| Project | IEEE 802.16 Broadband Wireless Access Working Group < http://ieee802.org/16 > | |
| Title | WirelessMAN coexistence function primitives consolidation | |
| Re: | IEEE 802.16-08/019 IEEE 802.16 Working Group Letter Ballot Recirc #29b: Announcement (2008-04-07) | |
| Abstract | Semantic consolidation on Coexistence Functionality primitives in 16h, moving CX proxy description into Annex and generalize the network address for basic connectivity between WirelessMAN-CX systems. | |

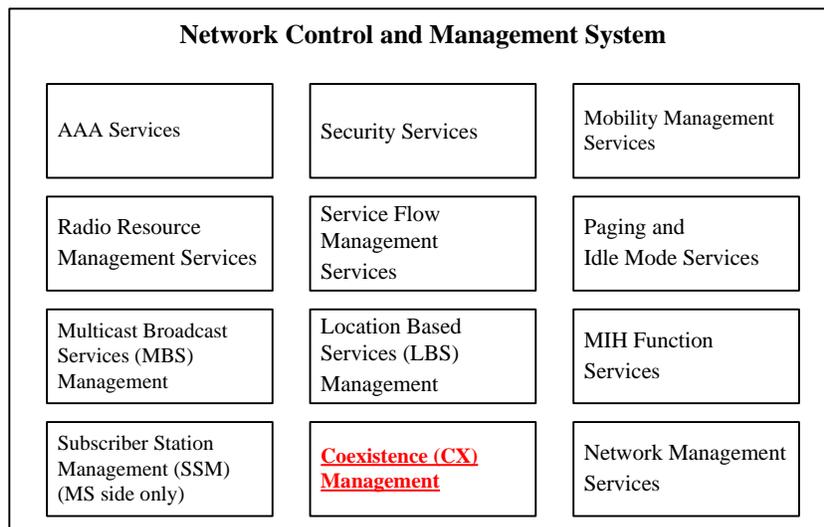
Modified the figure 3 in 1.4.4 accordingly:

Figure xx1. primitive flow of C-CX-REQ/RSP

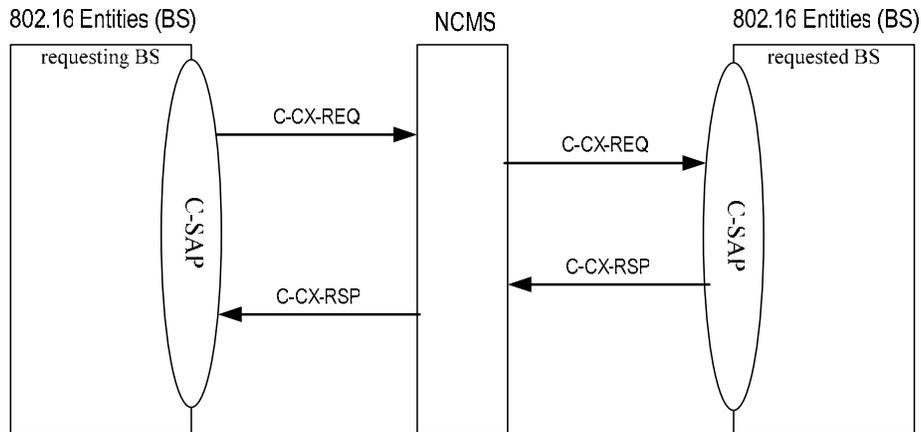
Add a new section 14.2.12 in 14.2, or replace according content in 15.6 with following:

The CX primitives are a set of primitives for supporting CX procedures between BS and NCMS.
